**In the Matter of Xcel Energy's 2020-2034
Upper Midwest Resource Plan**

PUC Docket No. E002/RP-19-368

SIERRA CLUB REPLY COMMENTS

JUNE 25, 2021

Figure 1: DOC Modeled Savings from Not Constructing the Sherco CC (\$mil)⁶

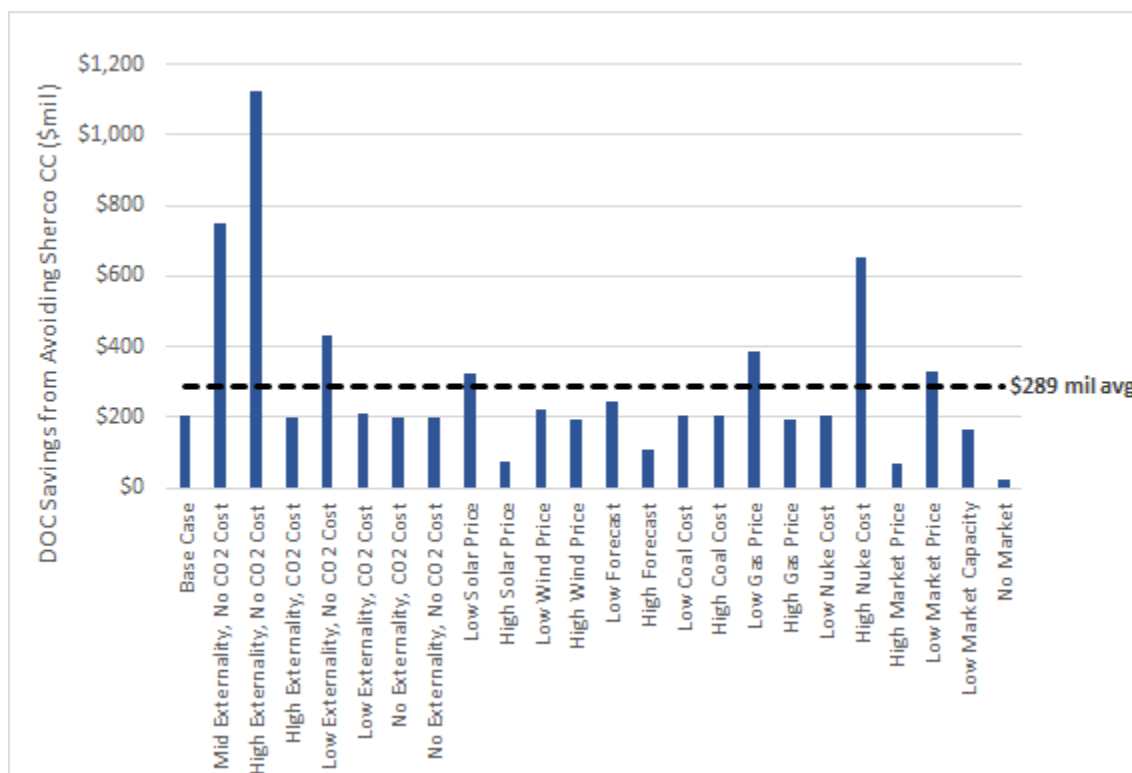
The Minnesota Department of Commerce's ("DOC's") Initial Comments focused on reviewing and analyzing Xcel's Strategist modeling.¹ This modeling review found that the proposed Sherco combined cycle gas plant ("Sherco CC") would be an uneconomic resource addition. The DOC hard-coded the Sherco CC into almost every scenario, but ran one "no Sherco CC" scenario (Scenario 134a) as a variation of its lowest-cost preferred plan (Scenario 134).² Comparing the Department's results of its preferred plan with and without the Sherco CC shows \$205 million in savings from not building the plant in the base case, as illustrated in Figure 1, below.³ DOC's calculated savings from removing the Sherco CC exactly matched our own, as presented in our Initial Comments.⁴ According to DOC's modeling results, not building the Sherco CC was cheaper in all futures, averaging **\$289 million in savings** across the 24 cases modeled by the Department, as illustrated in the chart below.⁵

The DOC’s Strategist modeling therefore confirms and supports our own modeling finding that the Sherco CC should not be approved as part of a prudent and least cost resource plan for Xcel.

Midcontinent Independent System Operator, Inc. (MISO) electricity interchange with neighboring balancing authorities 2/15/2021 – 2/19/2021, Eastern Time

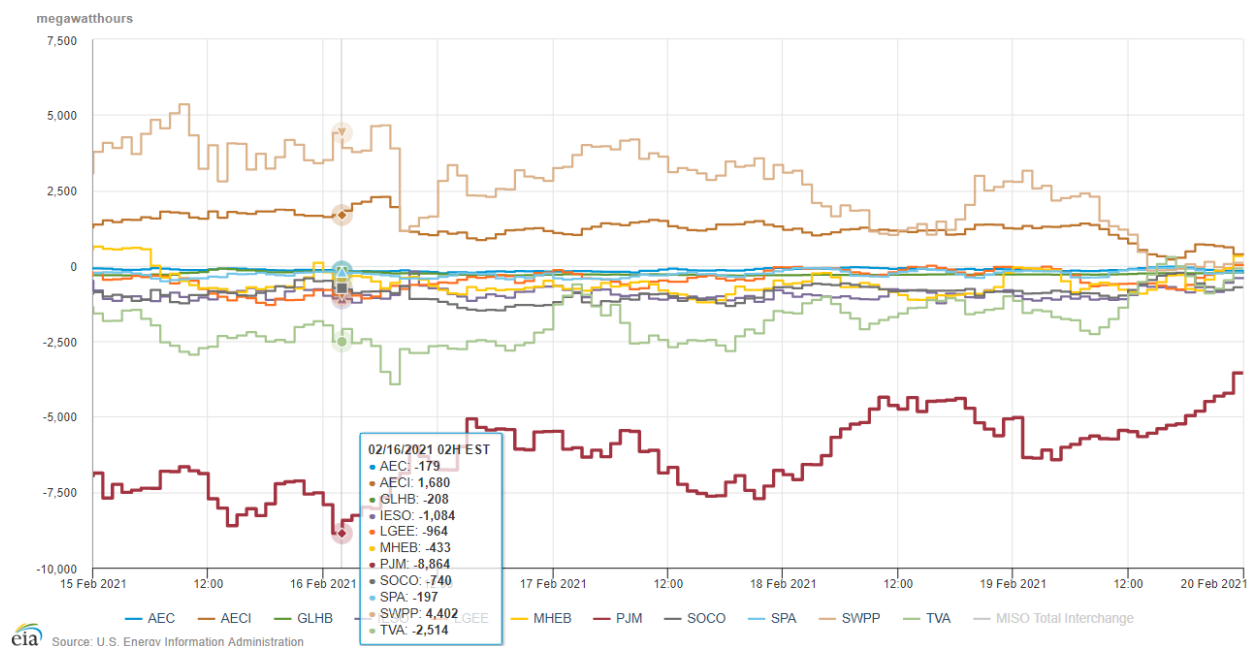
interruptions of gas supplies, because it was able to import more than 13 GW of power from neighboring power systems. As shown in the bottom half of the EIA chart below,⁷³ during the February 2021 extreme weather event, at maximum MISO was importing nearly 9,000 MW from PJM, several thousand MW from TVA, and around an additional 1,000 MW each from Southern Company, Louisville Gas and Electric, and Canada. Total MISO imports were consistently over 13,000 MW during the most challenging period from midday February 15 to midday February 16.

Electric Reliability Council of Texas, Inc. (ERCOT) electricity interchange with neighboring balancing authorities 2/14/2021 – 2/20/2021, Eastern Time

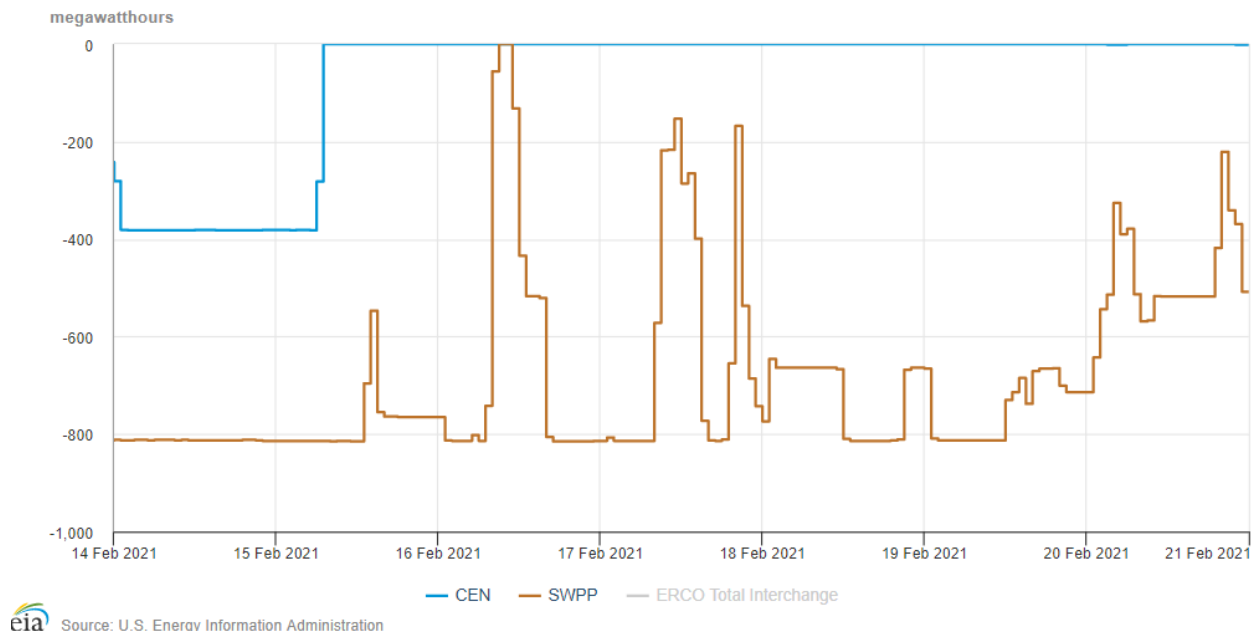
In contrast, the isolated ERCOT region was hit with days of extreme rolling outages, with curtailed load amounts regularly reaching 15 GW, because it lacks strong transmission inter-ties and was only able to import 800 MW from its neighbors. In contrast to the 13,000 MW MISO was importing during the peak of that event, ERCOT was only able to import about 800 MW of power, mostly from SPP, as shown below. ERCOT was initially able to import nearly 400 MW from Mexico, though those imports were cut early on February 15 when Mexico also experienced generator outages due to a loss of gas supply. Imports from SPP were also briefly cut at various points as SPP experienced its own shortages, particularly on February 16. If ERCOT had transmission ties comparable to MISO's, it likely could have weathered the event with little to no loss of load.

Electric Reliability Council of Texas, Inc. (ERCOT) electricity generation by energy source 2/15/2021 – 2/19/2021, Eastern Time

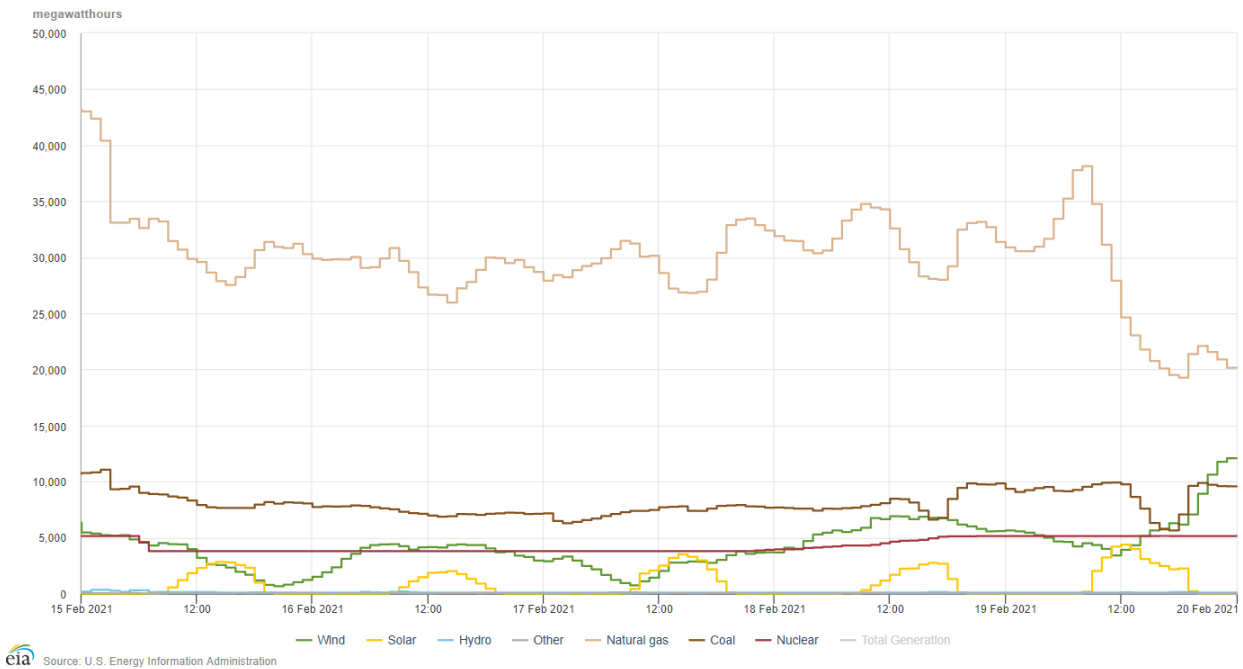
EIA⁷⁴ and ERCOT⁷⁵ data confirm that, while ERCOT coal, nuclear, wind, and solar plants also saw capacity taken offline due to the extreme cold, the loss of gas generation was the primary factor behind the extended outages in Texas. As shown below, a steep drop in gas and coal generation early on February 15 coincided with the start of the rolling outages in ERCOT, while wind output was relatively high. Solar output was high on each day of the event, as solar panels operate at a higher efficiency in lower temperatures.
